DEPARTMENT OF THE ARMY  
WILMINGTON DISTRICT, CORPS OF ENGINEERS

Action ID No. 199703132

Reference the Department of the Army (DA) permit issued to you on December 15, 2000, associated with the improvement to US 64 from Plymouth to East of Columbia, in Washington and Tyrrell Counties, North Carolina (TIP No. R-2548, State Project No. 6.149001T). Also reference your subsequent written request dated October 4, 2005, for a permit modification to modify the requirements of special condition aa. (wetland mitigation) in the USACE permit issued to you described above.

# R-2548 Modification Request

R-2548 Permit Modification

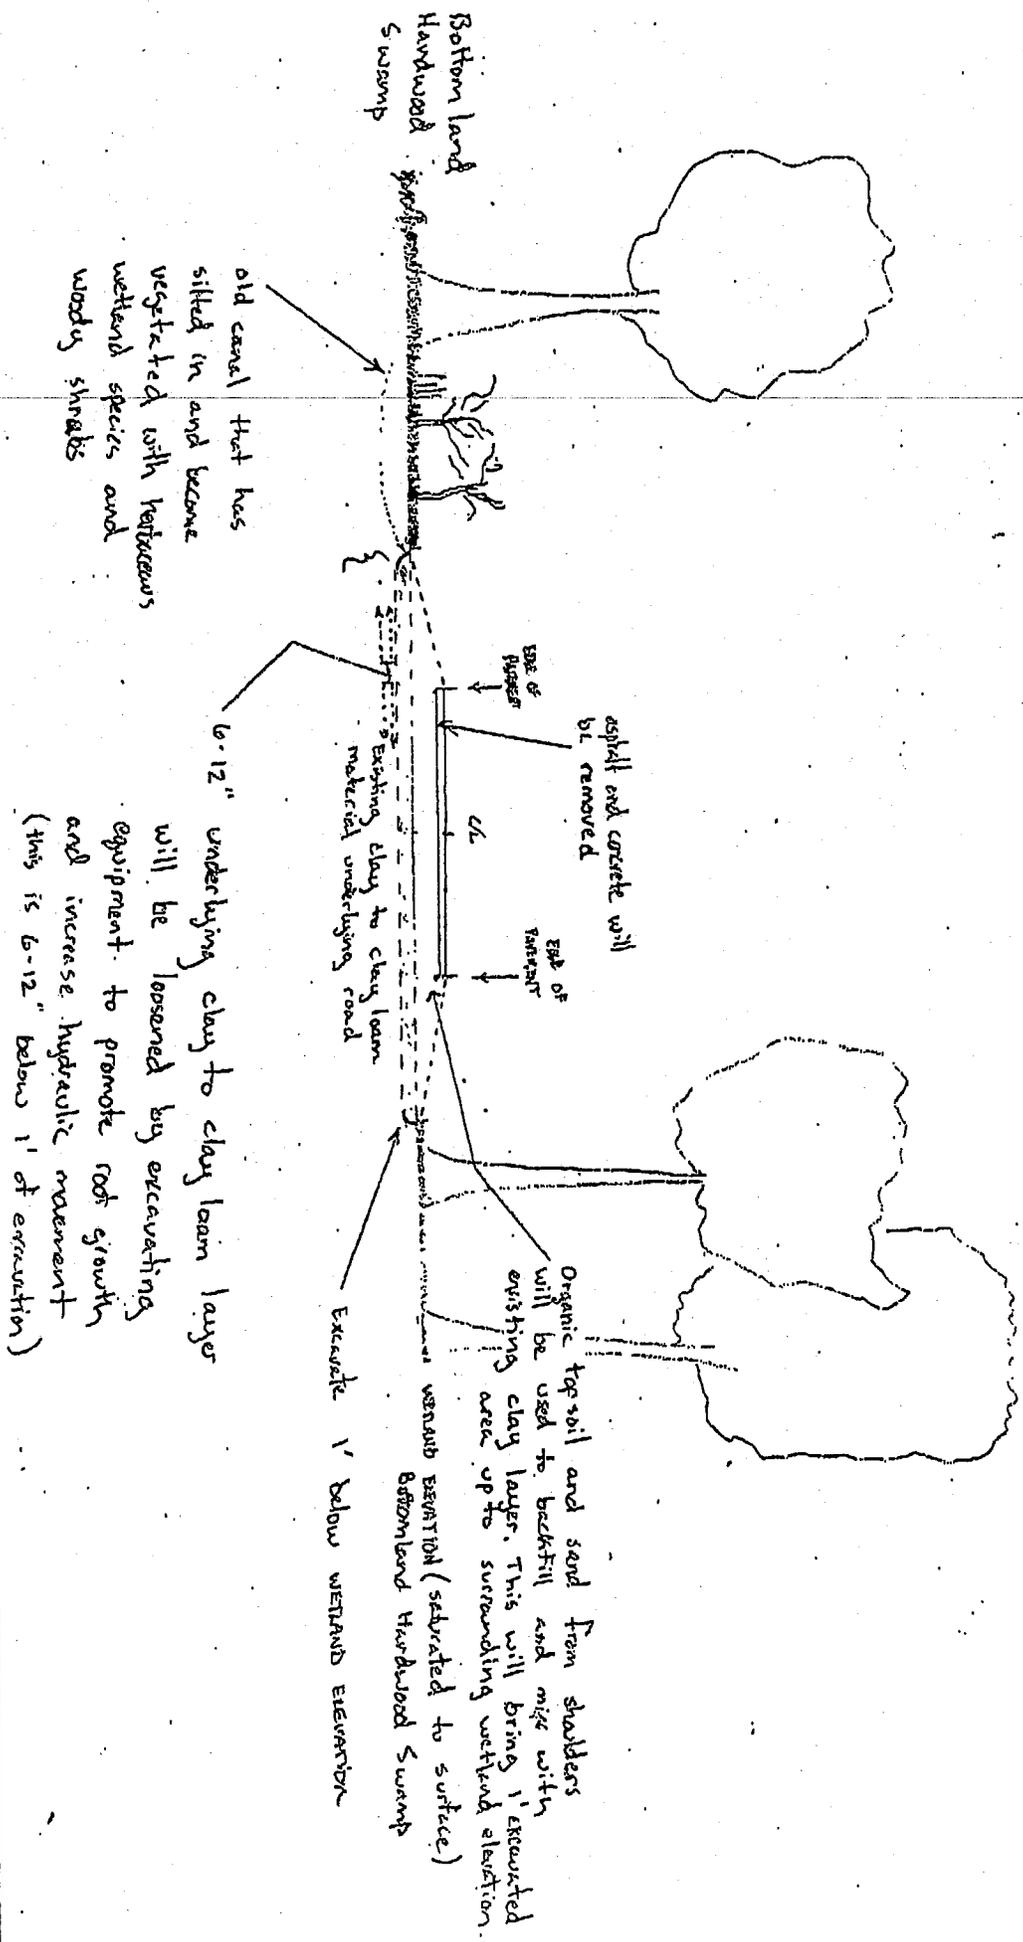
The original special condition (aa) required that 4,340 linear feet of the old U.S. Highway 64 be removed and graded down approximately 3.28 feet below the grade of the surrounding wetlands and back-filled with undercut material removed during the construction of the R-2548 segment to restore 6.13 acres of wetlands in an historic ox-bow area. Your modification request proposes to remove the existing roadbed down to the elevation of the surrounding wetlands and then undercut the area another 12 inches. The soil in this area will then be loosened using the excavating equipment and backfilled to the elevation of the surrounding wetland using backfill material consisting of sand and organic material obtained primarily from the shoulder areas along the 4,340 feet section of roadway that is being removed. Additional material if needed may be obtained from undercut materials from the Hwy 64 project and will be blended with the existing clay material resulting in a soil that is similar to the surrounding wetland soil.

This modification request was coordinated with the appropriate State and Federal agencies and the coordination revealed no objections to this modification request. Therefore, the permit is hereby modified in accordance with the specific work activities described above and in the enclosed plans. It is understood that all conditions of the original permit remain applicable and that the expiration date is unchanged. In addition, the permittee will comply with the following special permit conditions:

a. All work authorized by this permit modification must be performed in strict compliance with the attached work plans, which are part of this permit. Any modification to the permit plans must be approved by USACE prior to implementation.
